**Statement of Response to ABP's Opinion
in relation to ABP Ref.: 312108-21**

A Proposed Strategic Housing Development

**Site 10, Mayne River Avenue
Northern Cross, Malahide Road, Dublin 17**

John Spain Associates

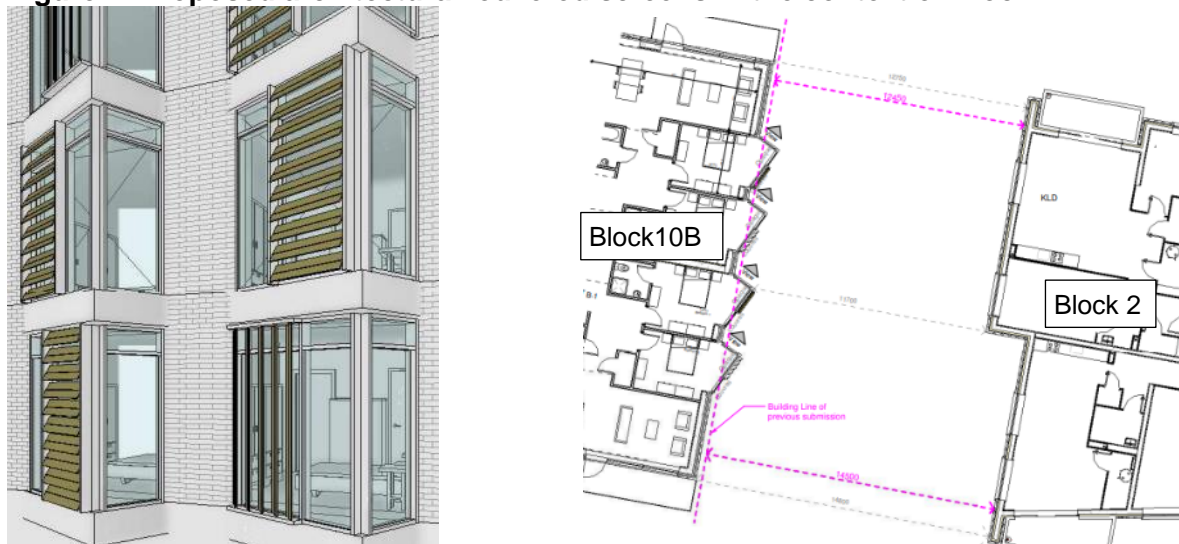
Further consideration and/or justification of the documents as they relate to the design and layout of the proposal having regard to the need to ensure no significant overlooking on the currently under construction Site 2 building. This further consideration may require amended to the design and layout of the apartments and /or reconfiguration of the blocks.”

In response to the foregoing specific item of further information requested by the Board, the proposed scheme was revised to ensure no undue overlooking of the permitted / under construction development on the adjoining Site 2 (Block 2). Please refer to the architectural
